# Design Review Board Agenda

**CITY OF MILL CREEK  
DESIGN REVIEW BOARD  
APPLICATION PL2018-0003**

**NAME OF PROJECT:** The Learning Experience (TLE) – Commercial Childcare Center

**PROPOSAL:** Review of building elevations, landscaping and monument sign

**Attachment 2 – Color Elevations**

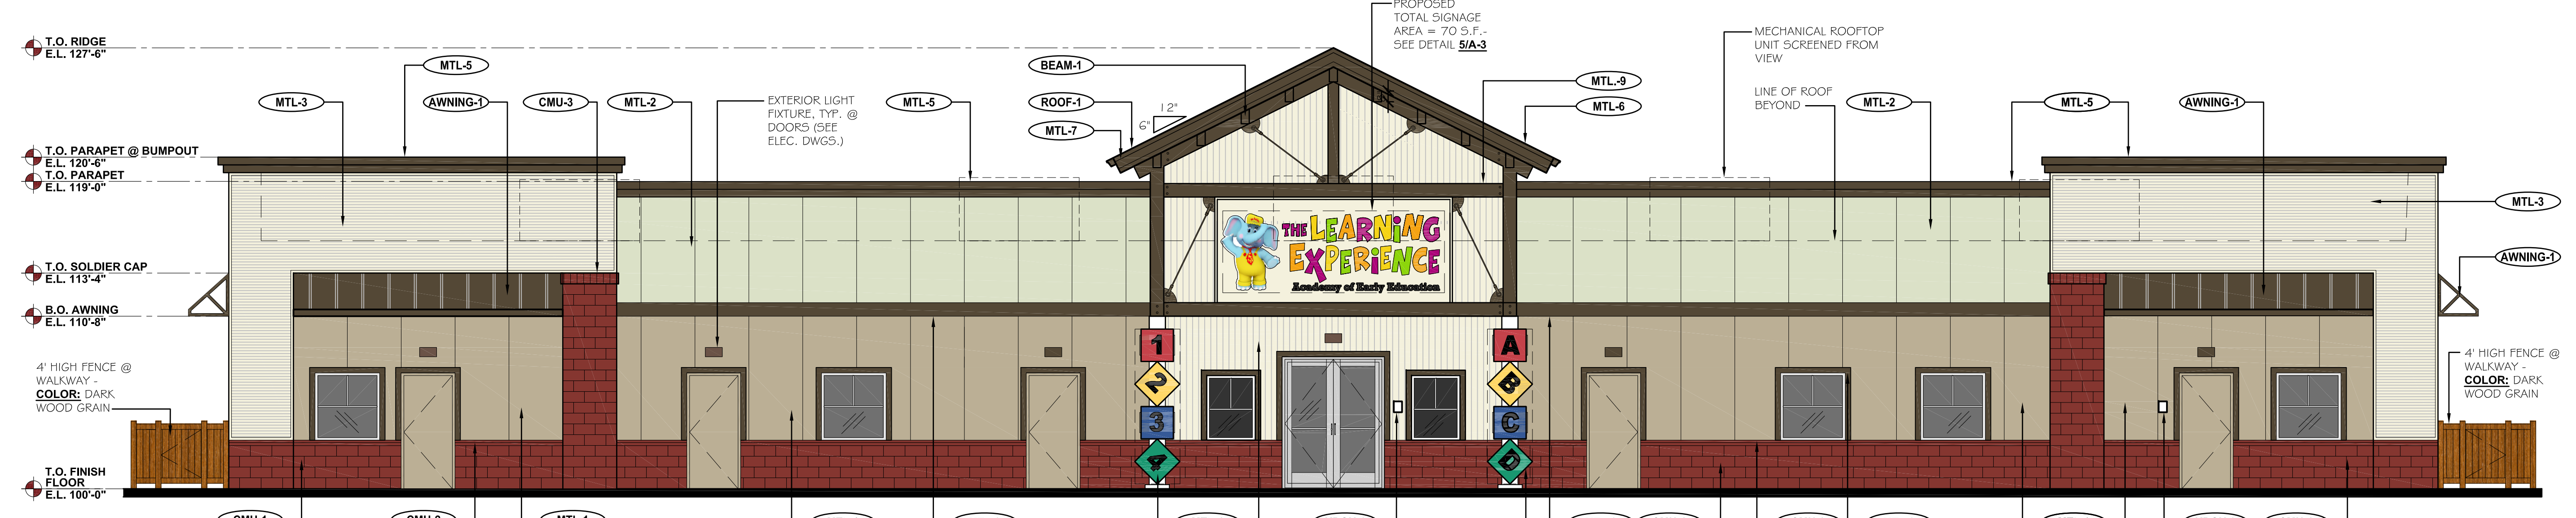
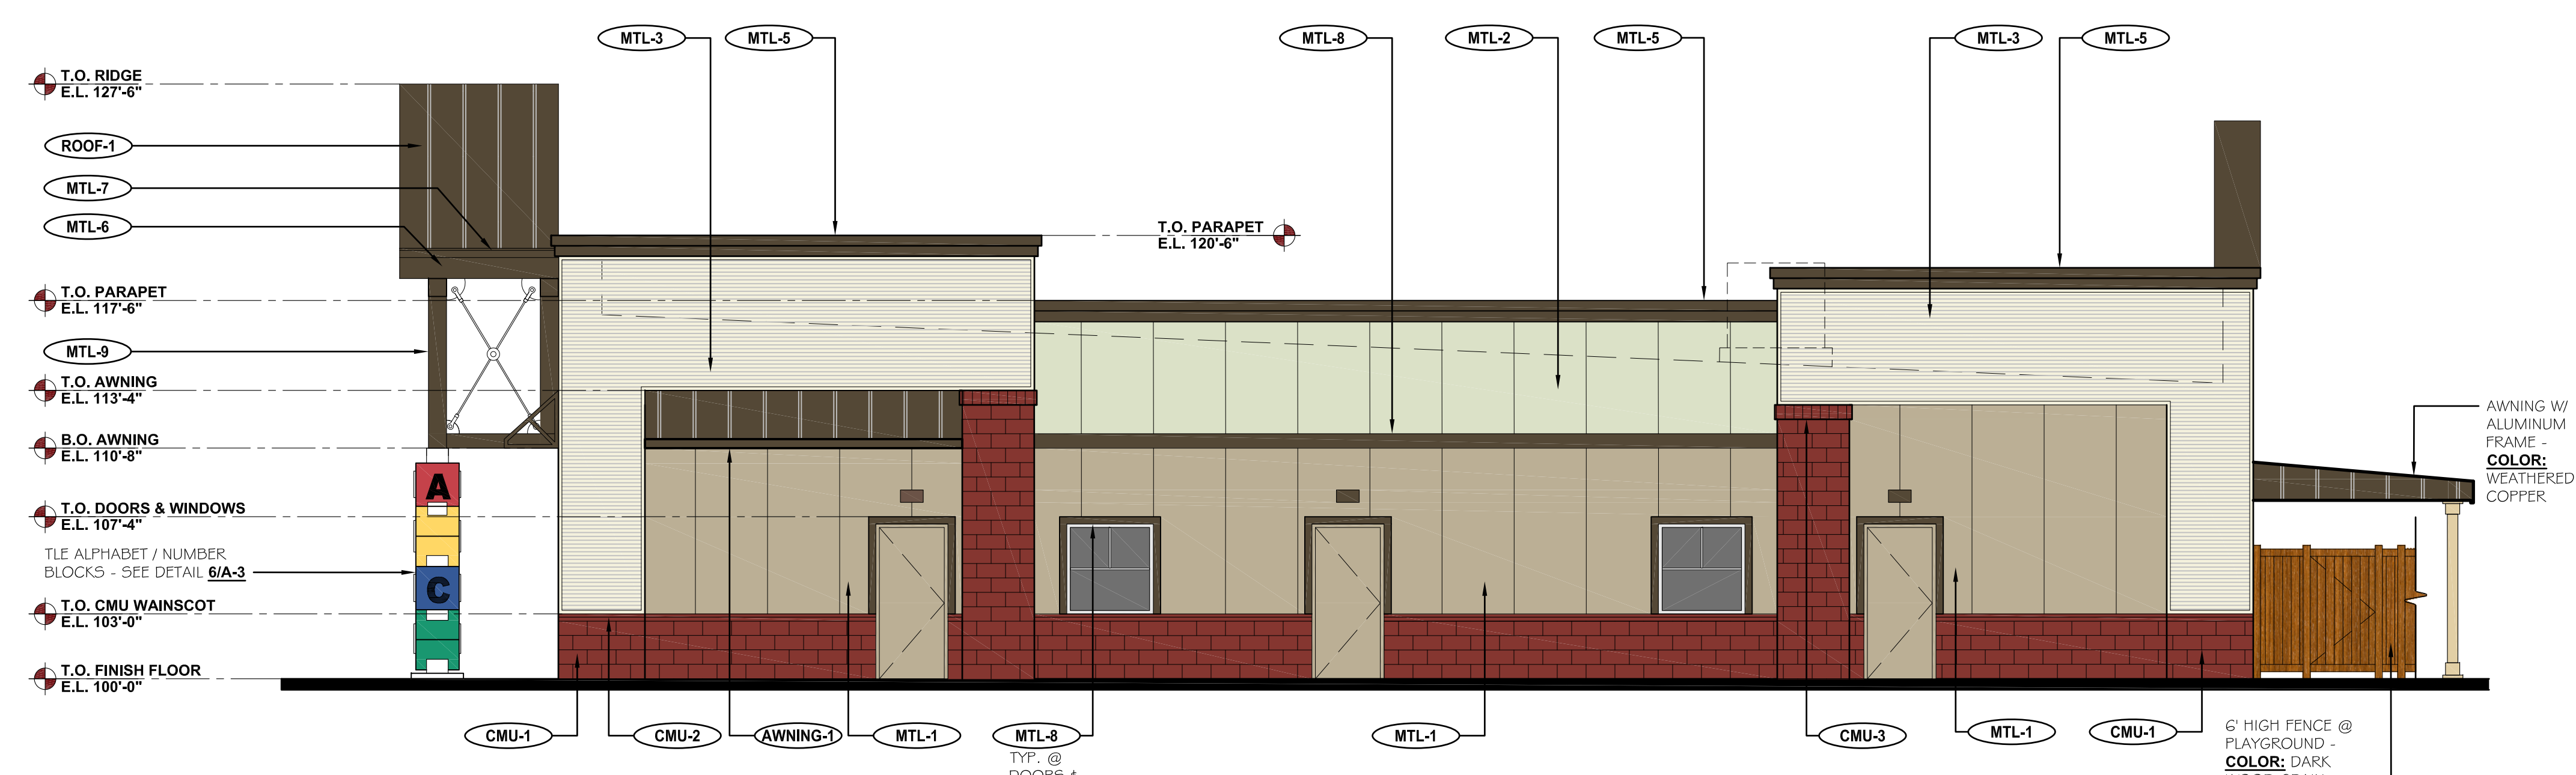
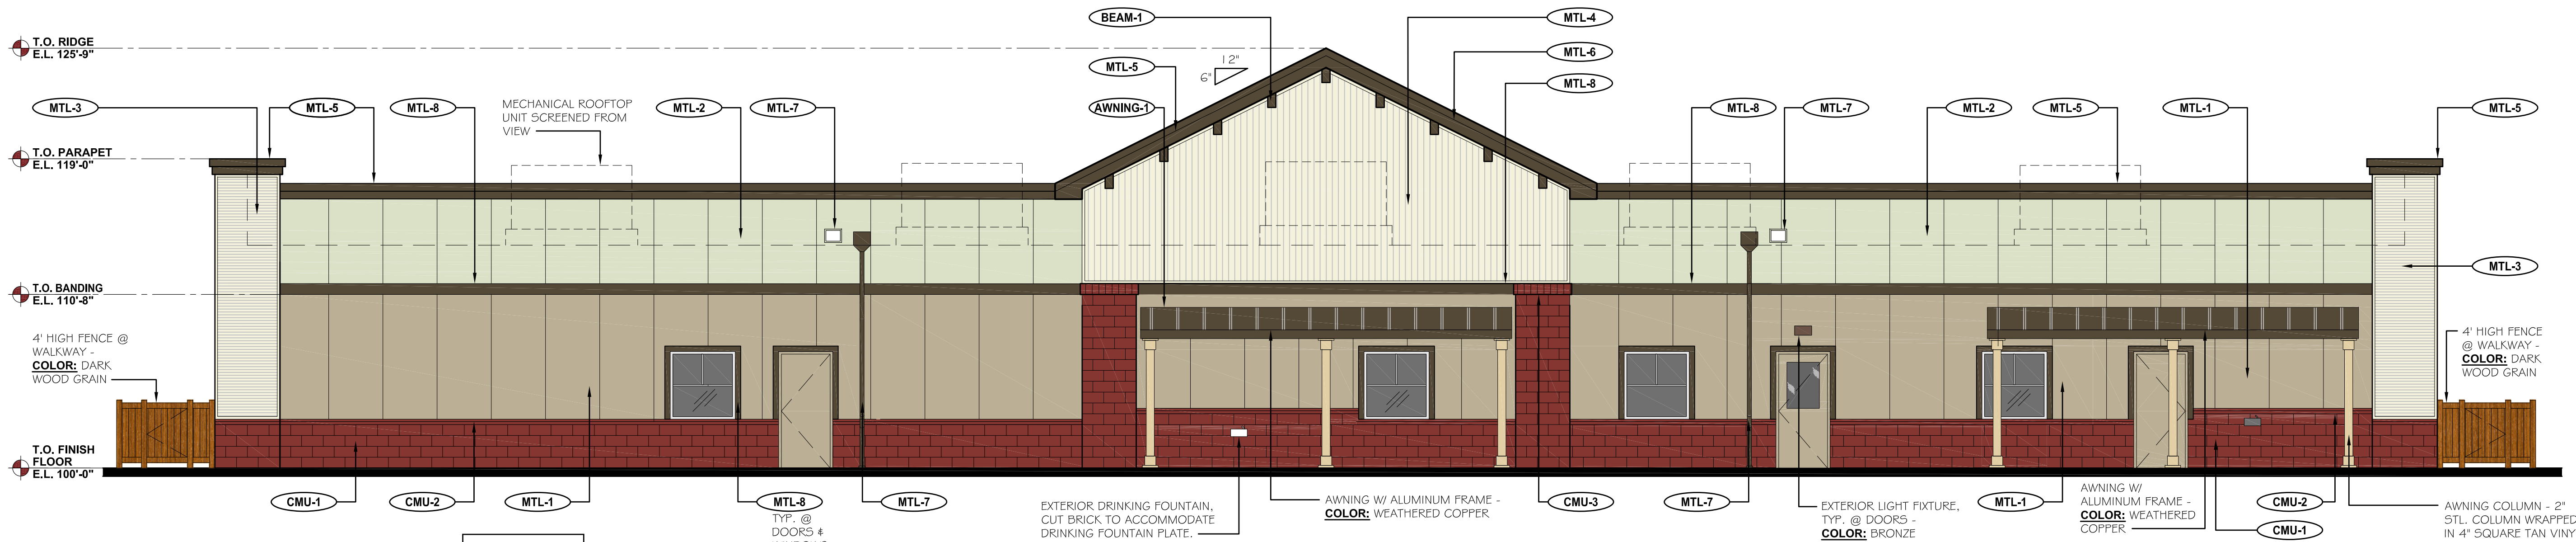
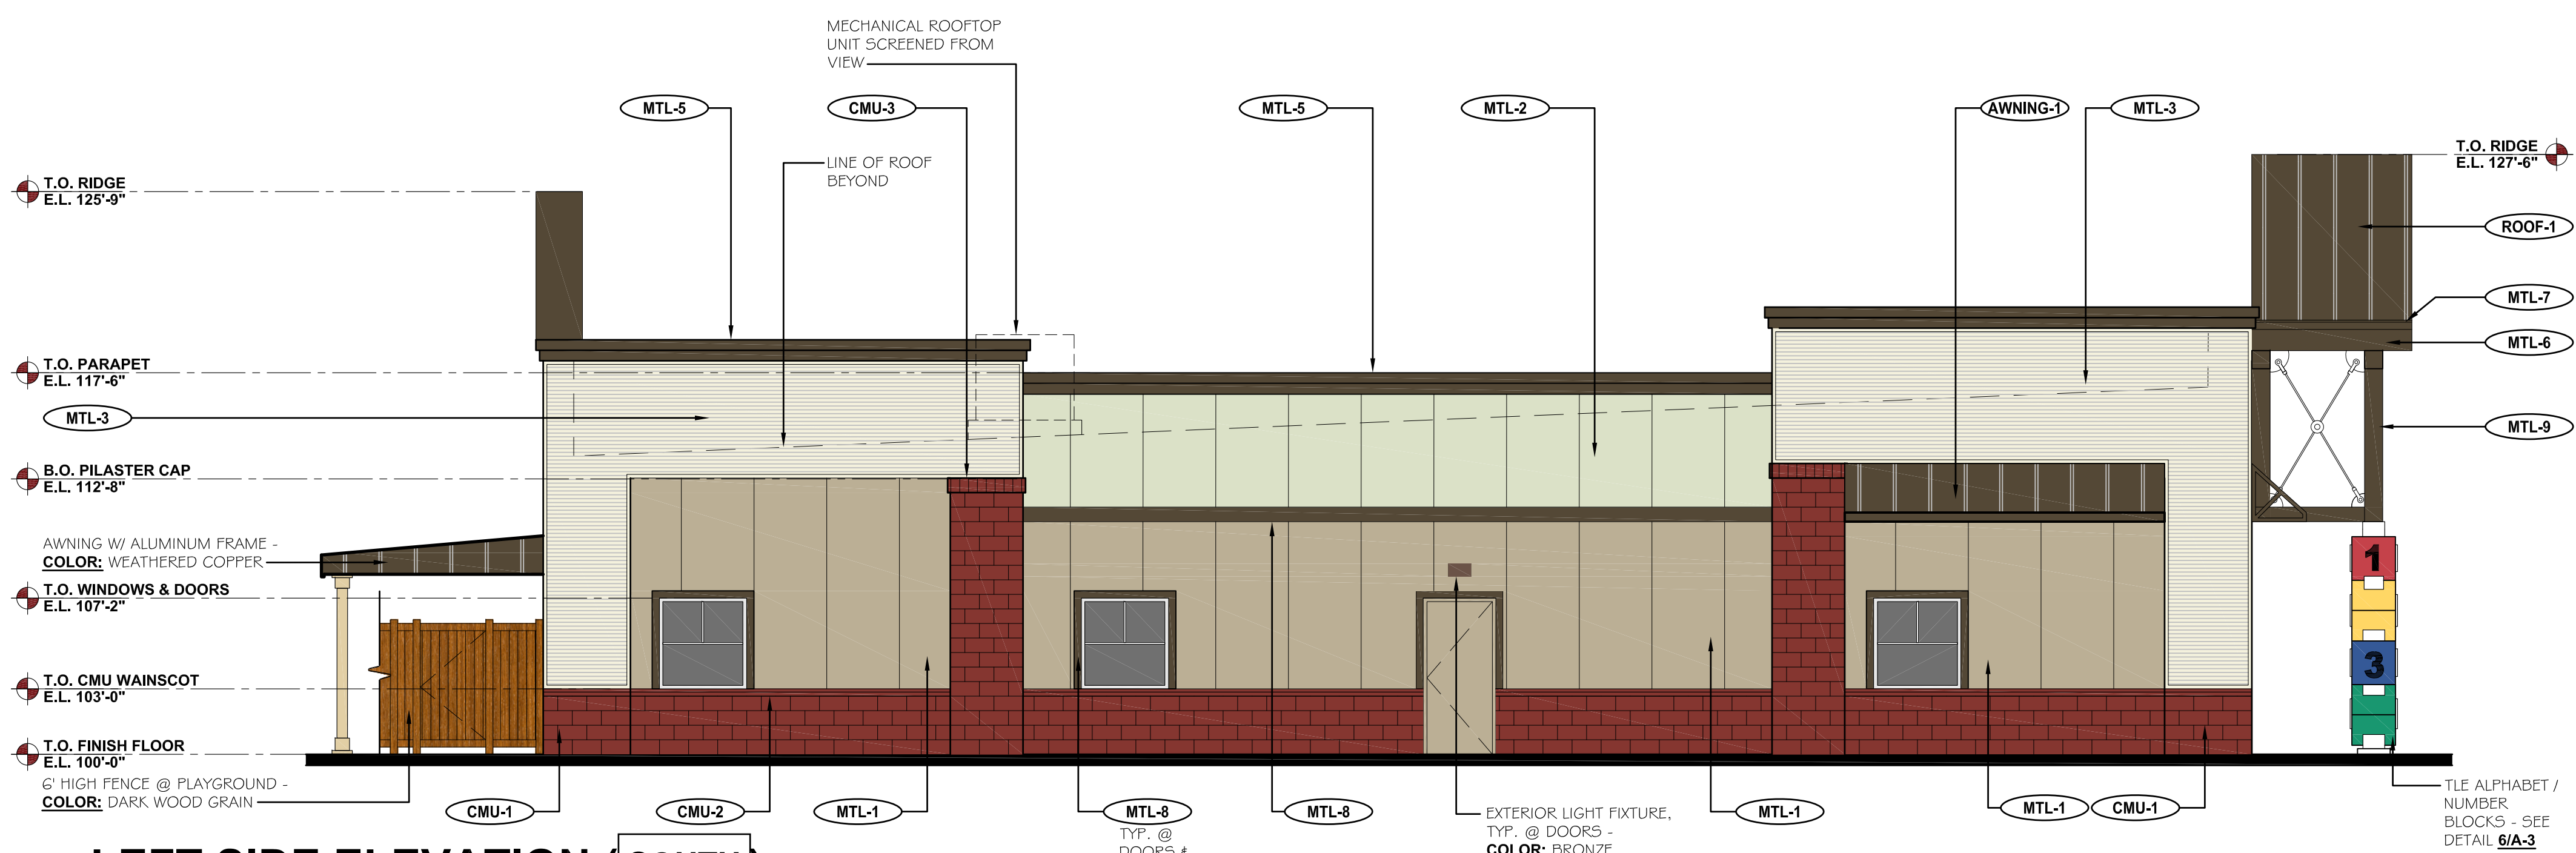
Changes recommended by the Design Review Board (DRB) during the informal review include:

- Changing the color on the top half of the building to Sandstone Beige
- Using either Trex or a high-quality, wood look vinyl for the fence
- Using a metal awning rather than vinyl for maintenance reasons.

All of these suggestions have been implemented.

As proposed, staff believes that the building elevations are in compliance with the design guidelines contained in the Code and is recommending approval.

1. The building elevations, materials, colors, and design shall be as portrayed in the application.
2. Amend the landscape plan as follows:
  - Select another species of street tree, either from the Approved Street Tree list or a species that is approved by staff.

**1 MONUMENT SIGN ELEVATIONS**  
 SCALE: 1/2" = 1'-0"

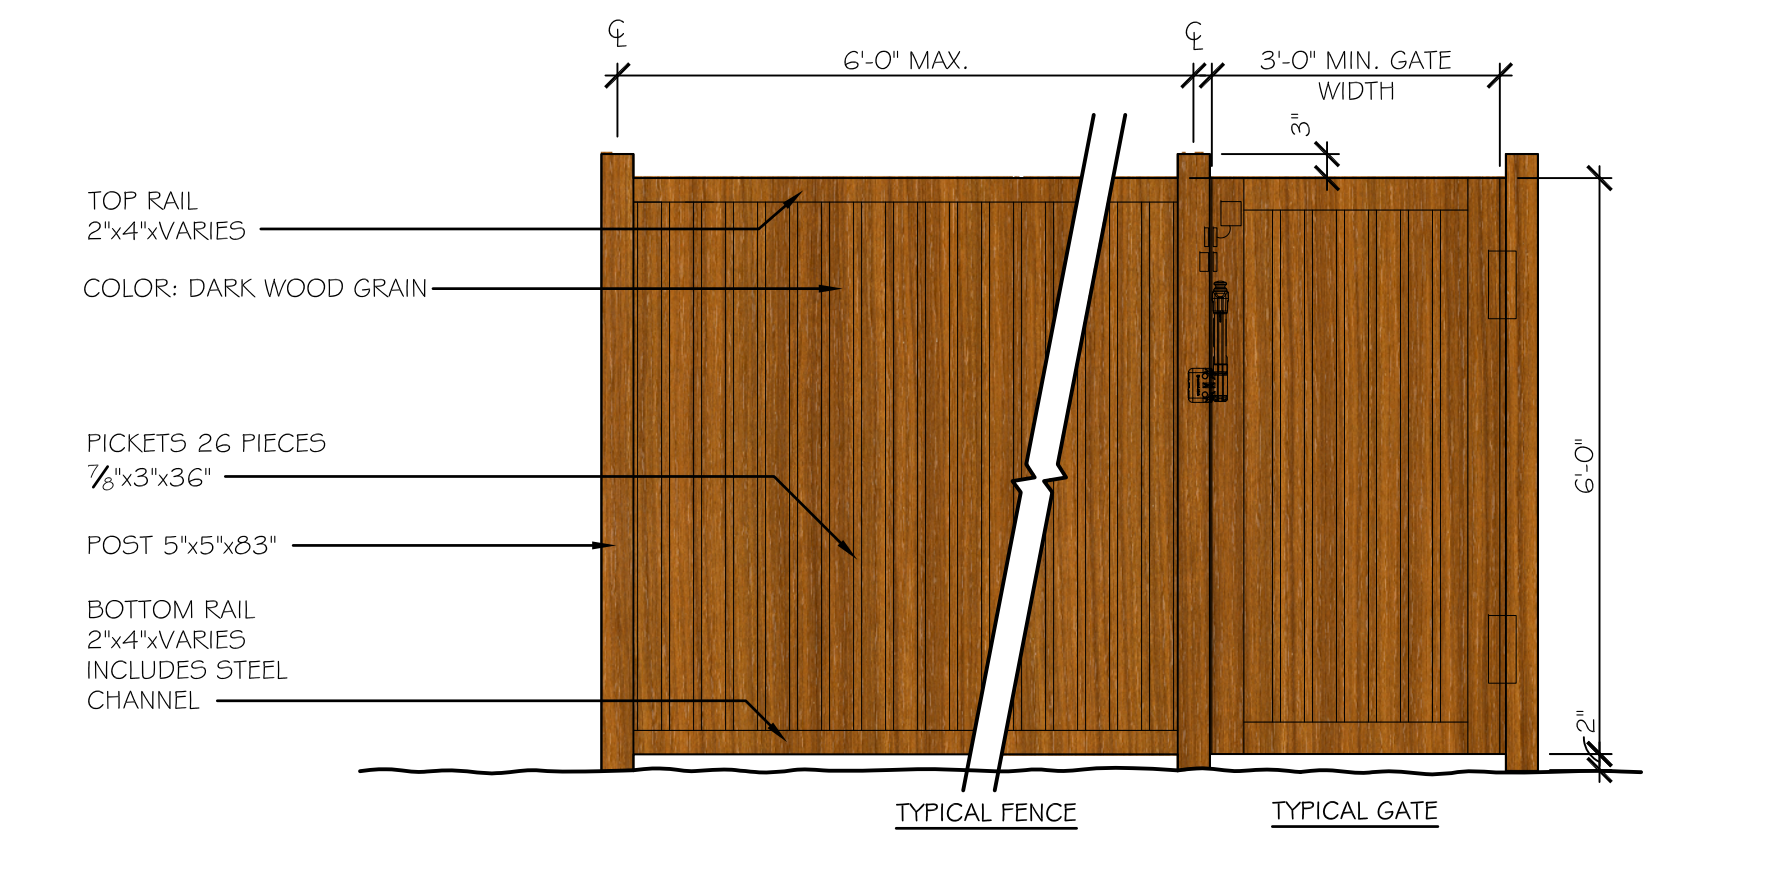
The supporting structure of the monument sign will be constructed with CMU in Fuego Red to coordinate with the building. The proposed sign itself is 13.33 square feet and the sign including the supporting structure is 32.66 square feet with a height of 42 inches, which meets the dimensional requirements contained in the Code. The sign itself will be the business name and logo in acrylic letters pin mounted on a stucco background. The lettering and logo are in bright colors. In addition, the sign meets the minimum 5-foot setback requirement contained in the Code. It will be up-lit with ground mounted spot lights on each side. The design of the freestanding sign was reviewed by the DRB in the informal review and found to be acceptable if it was reduced in size to meet the dimensional requirements contained in the Code, which has been done.

As proposed, staff believes that the proposed freestanding sign is in compliance with the design guidelines contained in the Code and is recommending approval.

**6 ENTRY BLOCKS**  
 SCALE: 3/4" = 1'-0"

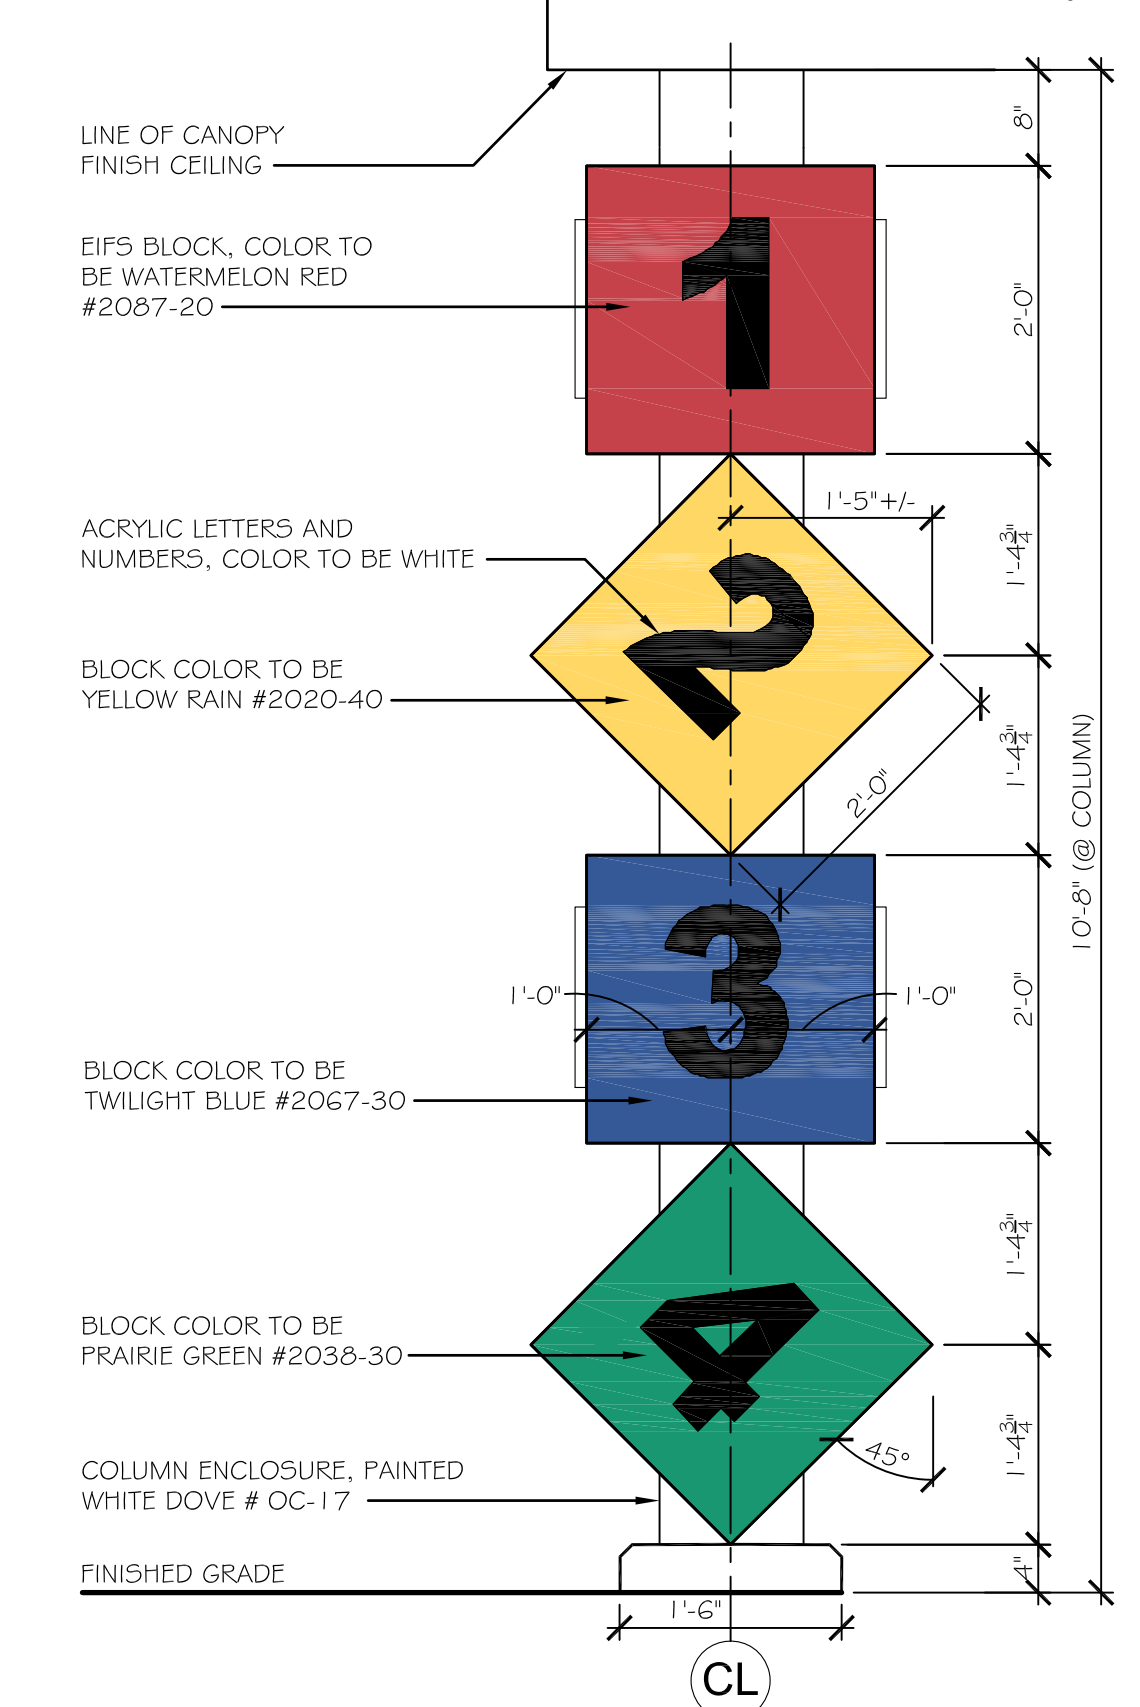
For the case of the The Learning Experience, the blocks and letters are part of their franchise style, which I believe the board has the right to "strongly discourage". I pulled a picture from their website showing a facility in Brighton, CO (attached). Since the blocks are subject to review as you noted below, then the DRB can "strongly discourage" those elements. Can you provide some guidance on "strongly discourage"? Can we vote against those elements?

entrance columns is not for advertising purposes, but to provide a clearly identified main entrance that is interesting to their clients, young children. The blocks on the columns, given their distance from the road and the presence on the roadway buffer, will not by themselves, attract attention from the highway. The proposed wall sign, which is reviewed by staff, serves the purpose of identifying the business name and serve an advertising purpose.

The answer to this question is yes. The proposed blocks on the entrance columns are part of the building elevations and are subject to the Design Review Board finding that the project is consistent with the design objectives in MCMC 17.34. Staff's opinion is that the proposed blocks on the entrance columns are consistent with the building design objectives highlighted above. Staff supports and encourages such treatment to the building elevations. There are many examples of building architectural treatments in Mill Creek being complimentary to the business name or use. Some of these are: Light House Storage, Arena Sports, and Kinder Care School/Childcare. Graphic film on windows is also used on many businesses in the City.
